**REVISION 003 TO A  
 INVITATION TO TENDER**

<b>Title:</b> Grice Bay & McLean Point Remediation – Pacific Rim National Park Reserve	
<b>Solicitation No.:</b> 5P468-21-0110/A	<b>Date:</b> January 20, 2022
<b>Amendment No.:</b> 003	
<b>Client Reference No.:</b> 1568	
<b>GETS Reference No.:</b> PW-21-00980058

## Amendment 003

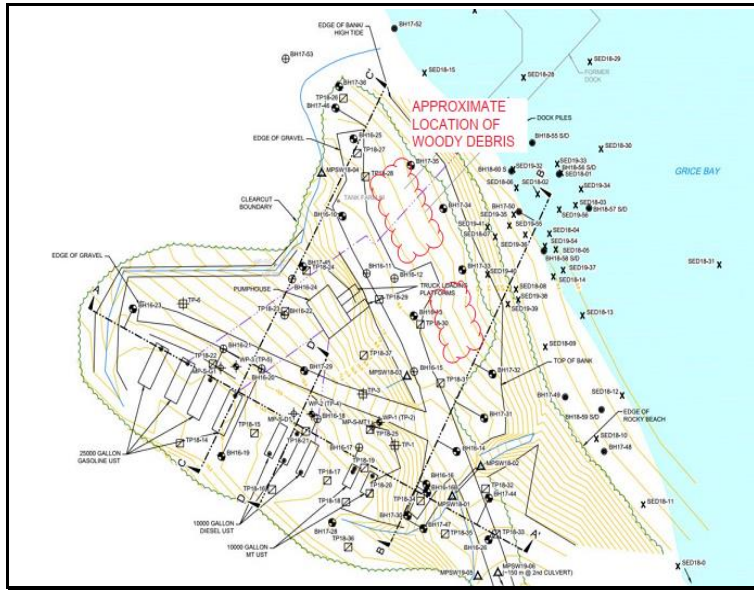
**Q17:** Can you please provide an outline of the area(s) at McLean Point that will be made free of bushes and successive growth prior to the start of this contract?

**A17:** The areas to be cleared by others at McLean Point will roughly coincide with the Tree Line perimeter indicated in the Project Figures. It should be noted that a portion of the cleared area within the Tree Line east of the access road contains Woody Debris from previous clearing efforts. This material will not be removed by others prior to the start of the contract. See markup of 123221826\_003\_Site-McLean Dwg below for clarification.
